City of Richmond

Report to Development Permit Panel

File: DP 18-818161

Re: Application by Christopher Bozyk Architects Ltd. for a Development Permit at 5660 Parkwood Way

PLAN # 1A
A00

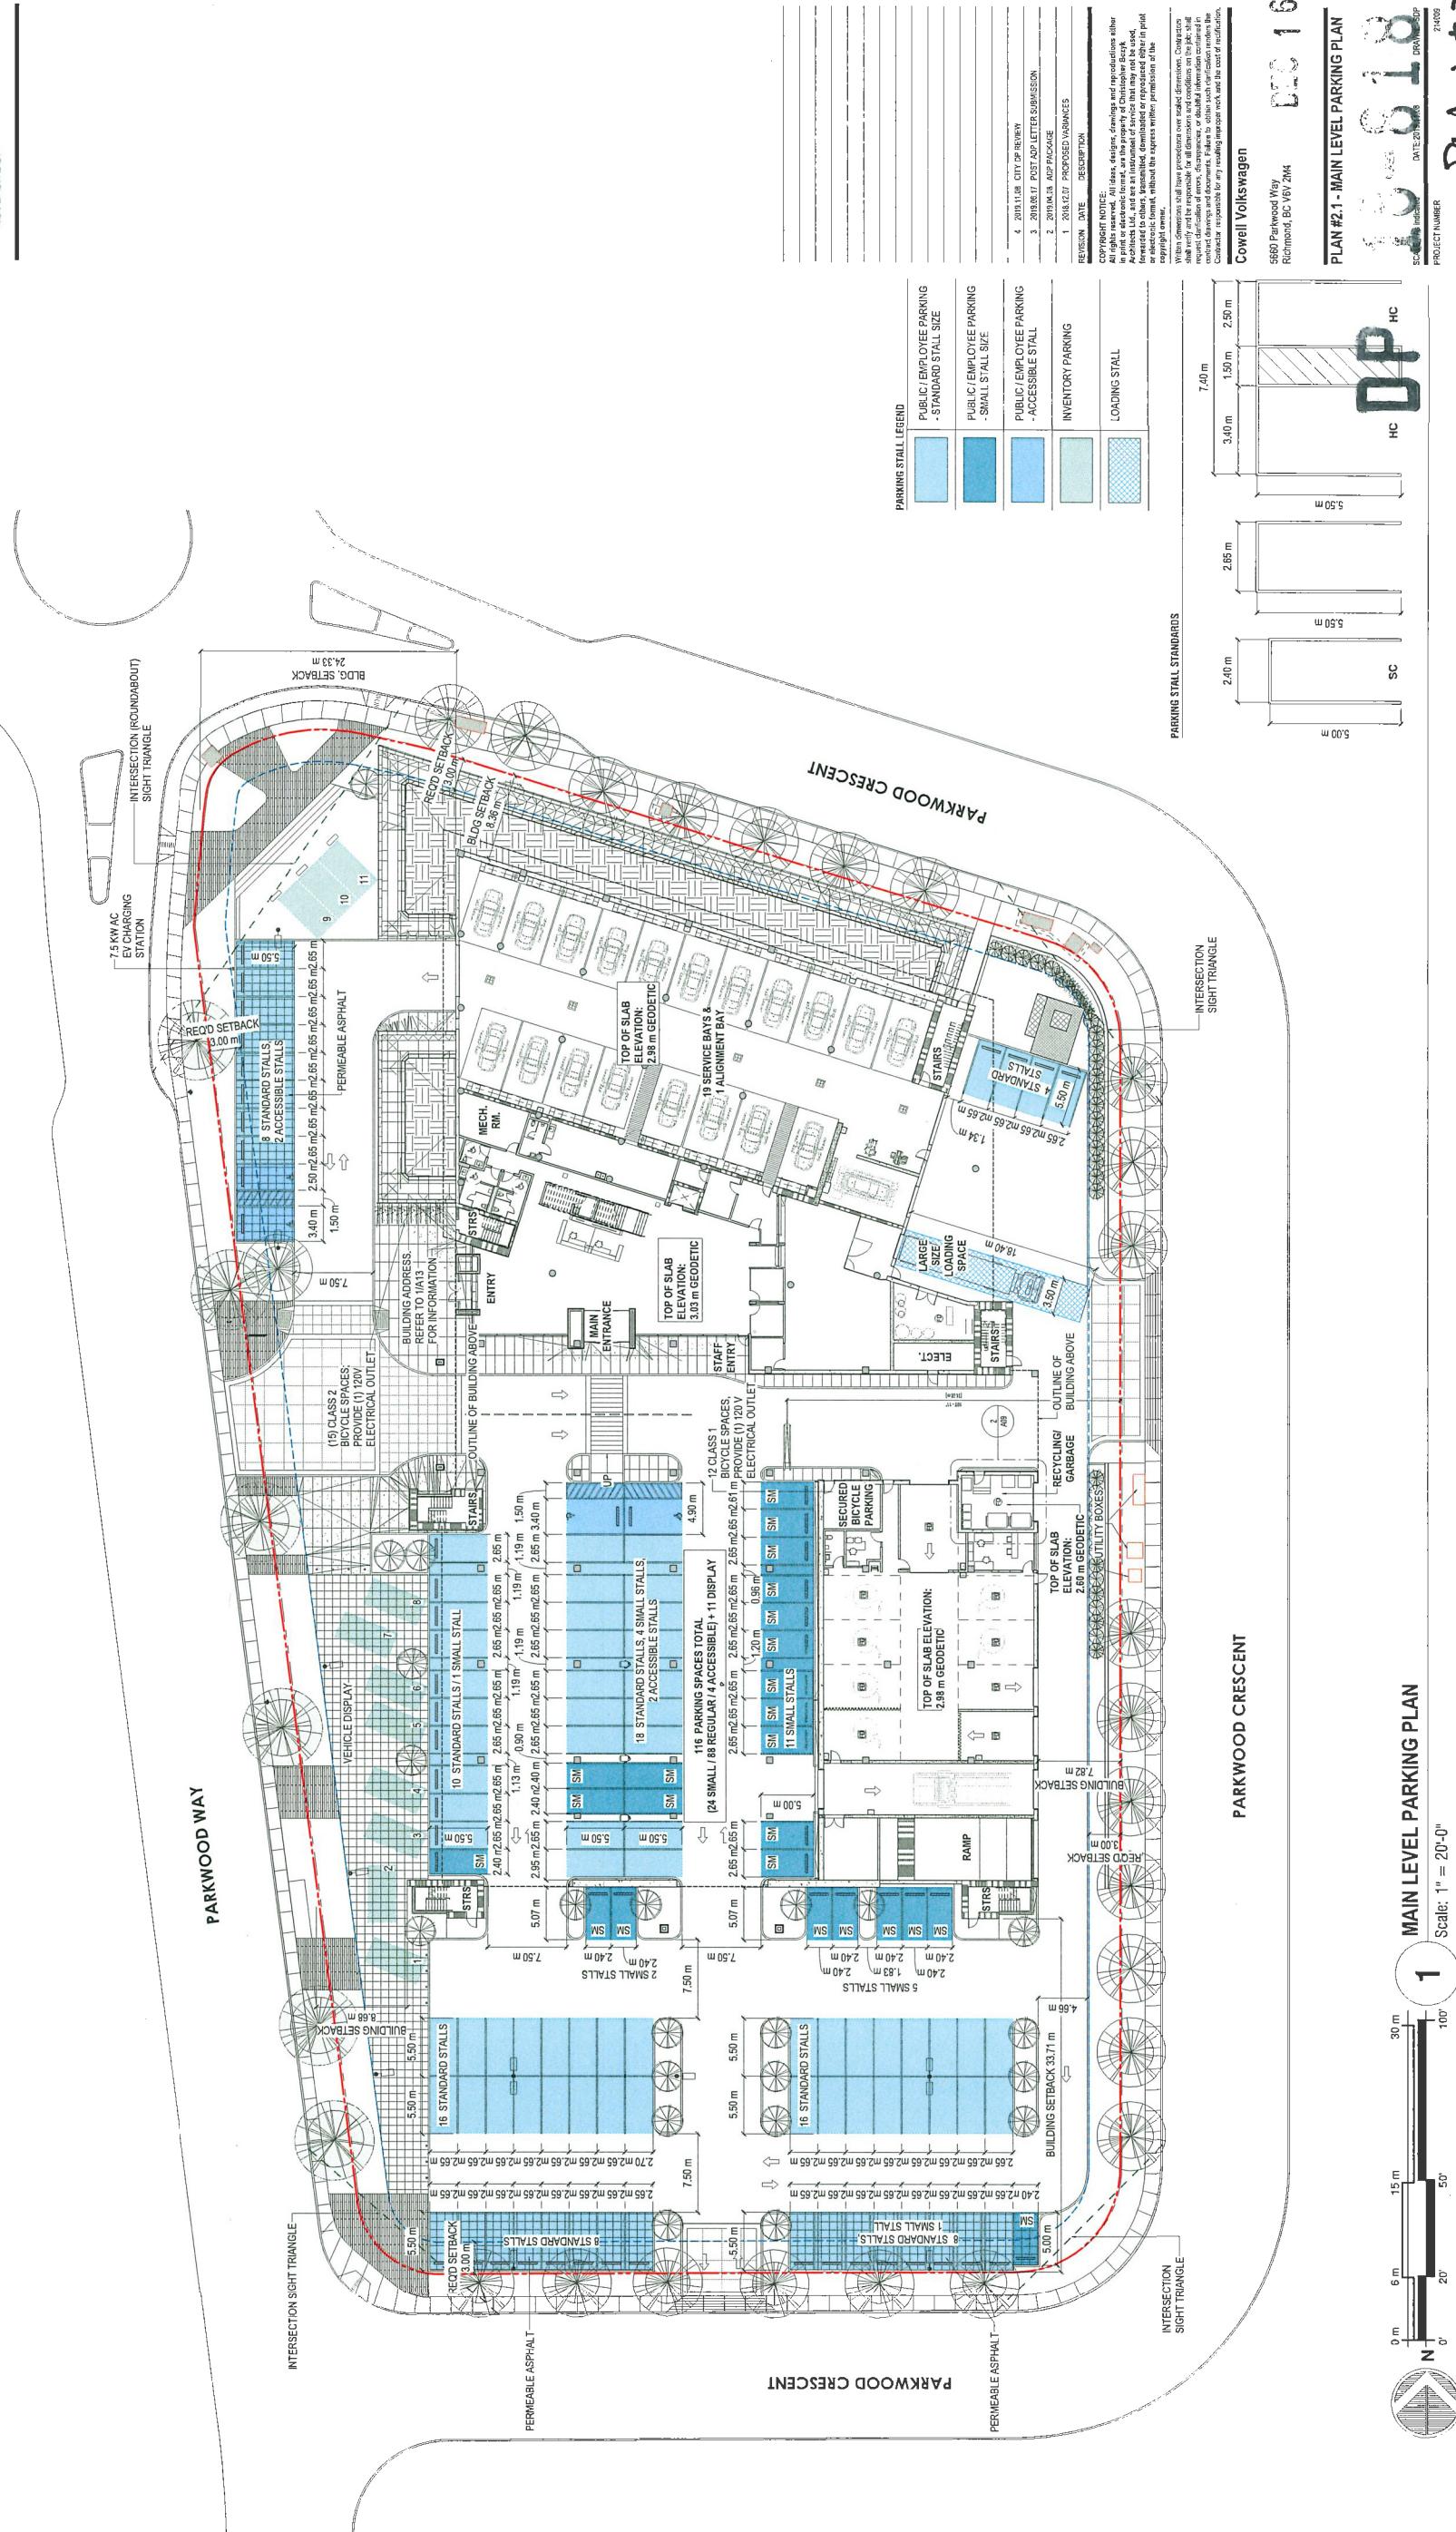
- support the Panel comment for the applicant to consider installing additional electric vehicle charging stations for public use;

Additional future locations have been added. Refer to sheet A00 "Site Plan."

The proposed variances are shown clouded on Plans #1.c, #2.a, #4.a and #4.b, and are supported by RAMA (as confirmed in Attachment 2).

PLAN #3B

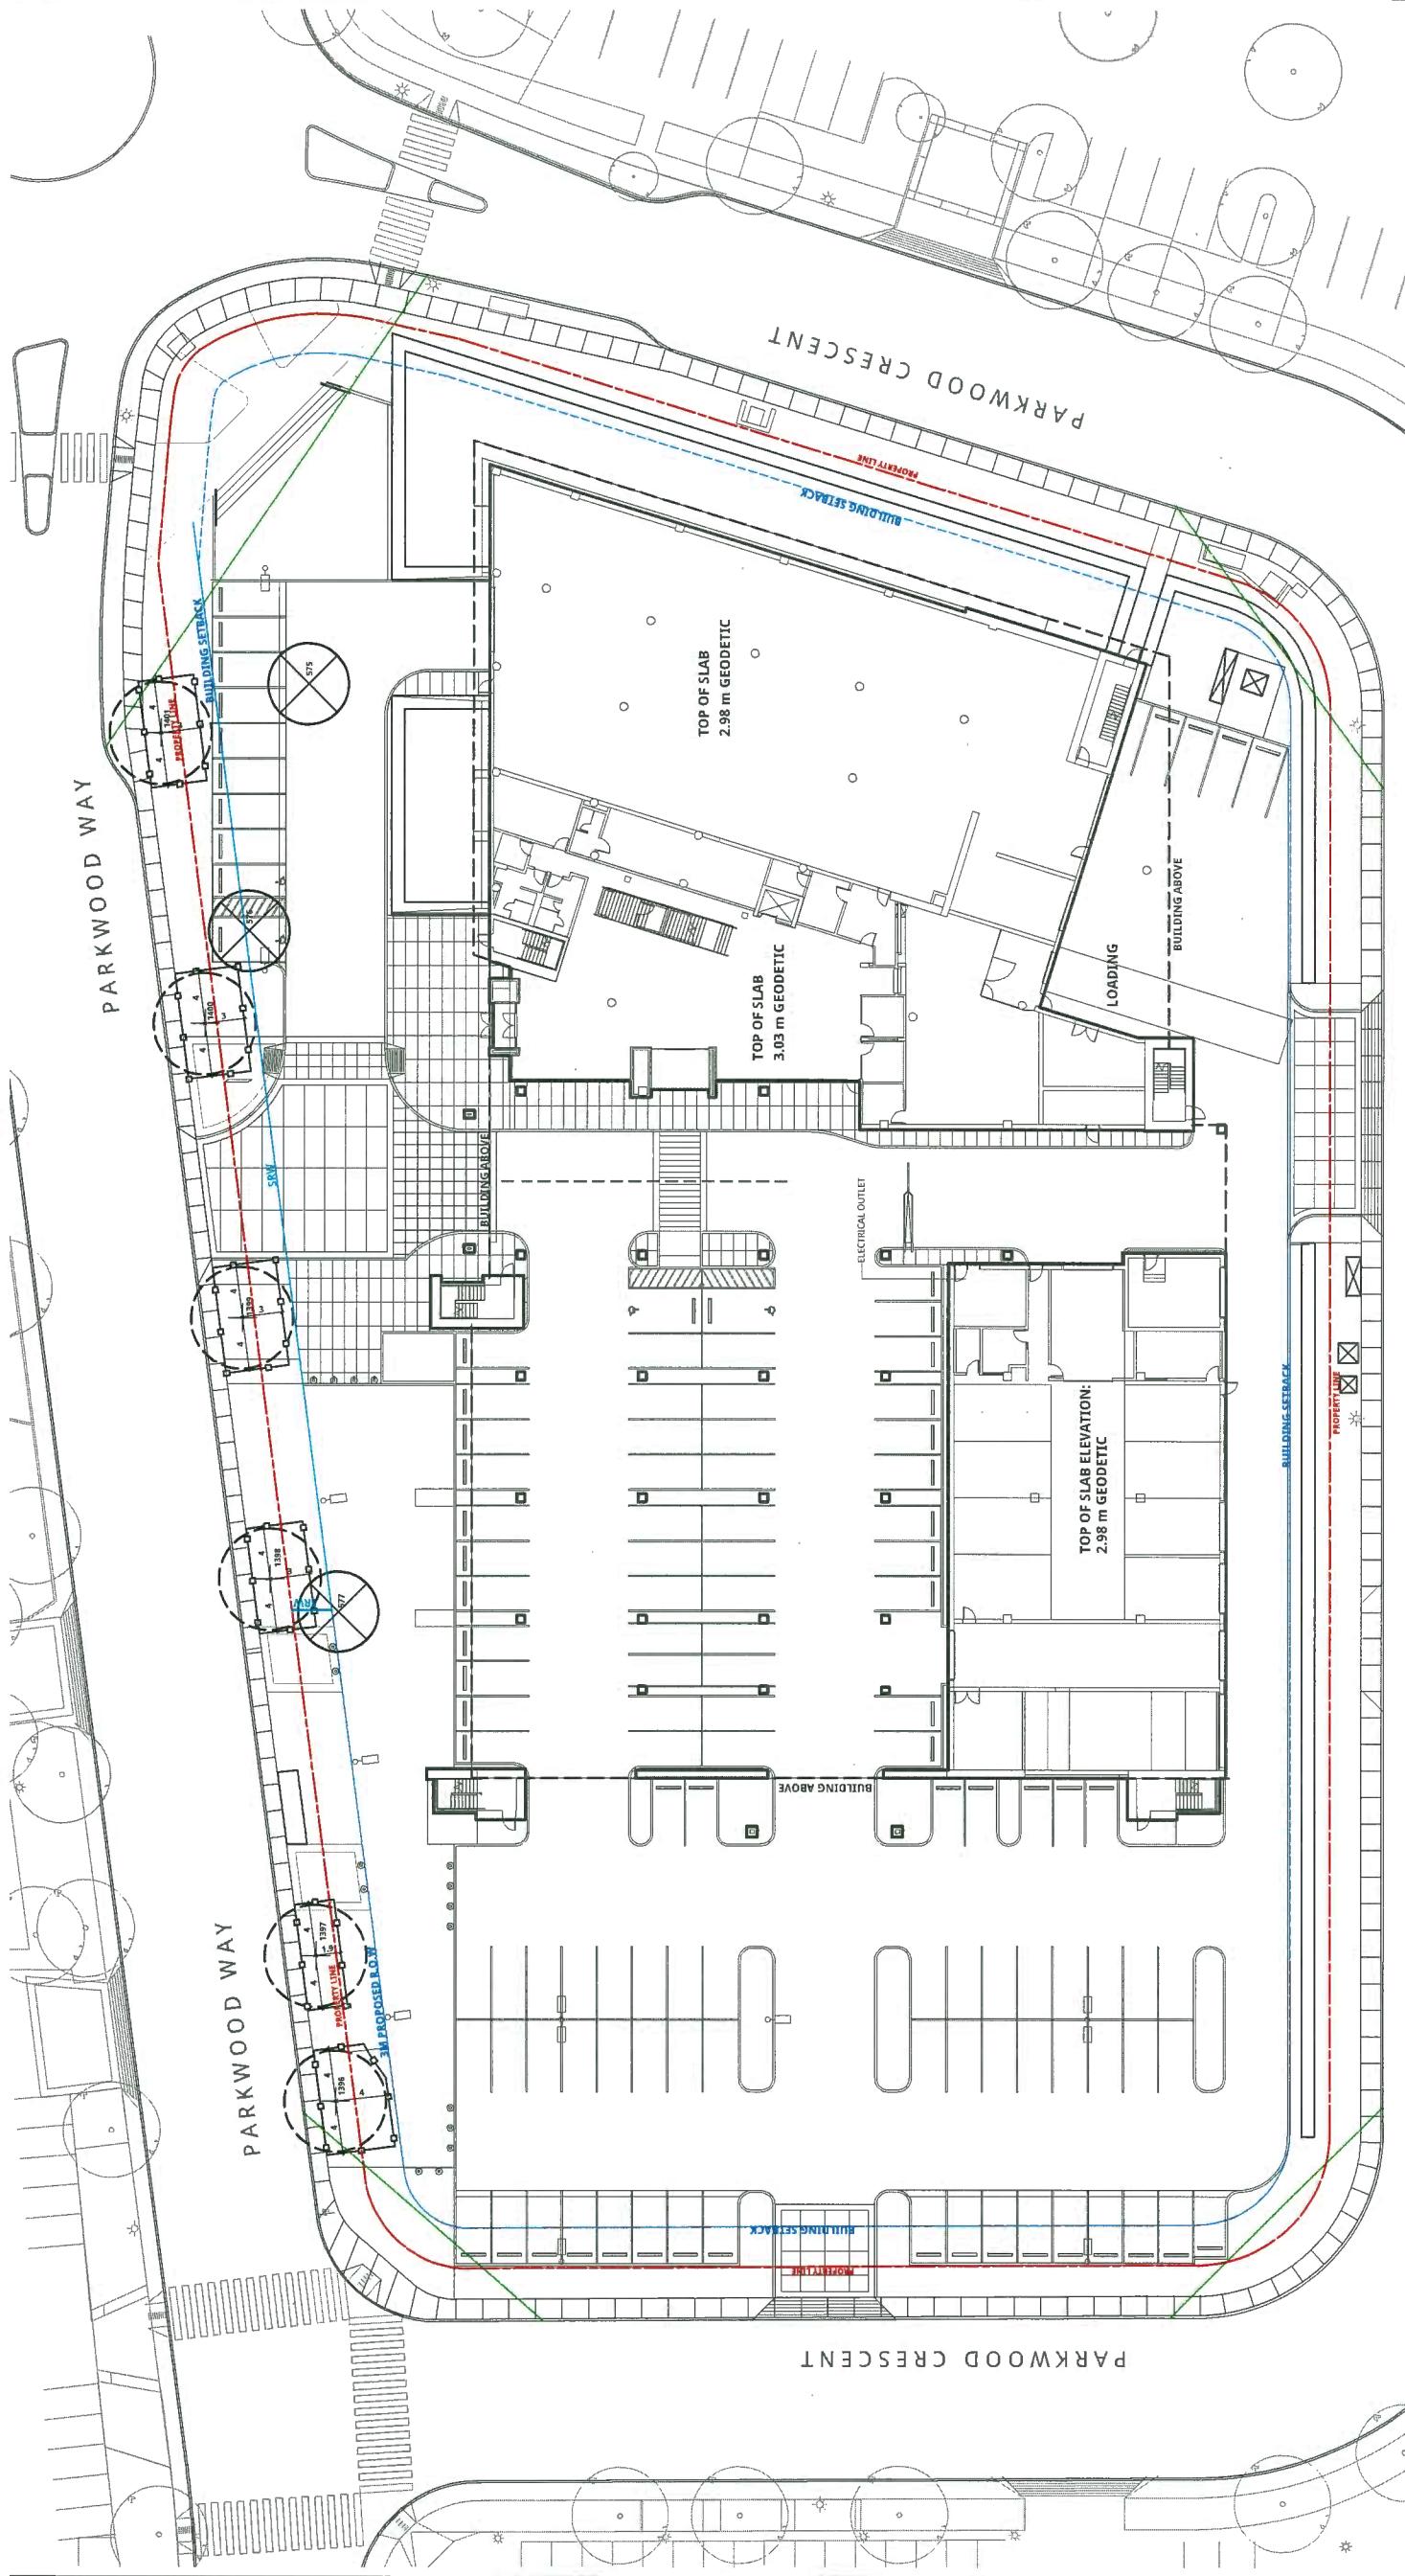
- Tree retention and removal was assessed as part of the Zoning Text Amendment application, and is illustrated in the Tree Management plan forming part of the Development Permit (Plan #3.b). Six existing City street trees within the boulevard along Parkwood Way are to be protected and retained, and three on-site trees are proposed to be removed. The Landscape Plan illustrates that 46 new trees are proposed to be planted and maintained on-site, well in excess of the OCP's 2:1 tree replacement ratio, and that 23 trees are proposed to be planted off-site within the City boulevard all along Parkwood Crescent (to be finalized through the Servicing Agreement design review process).
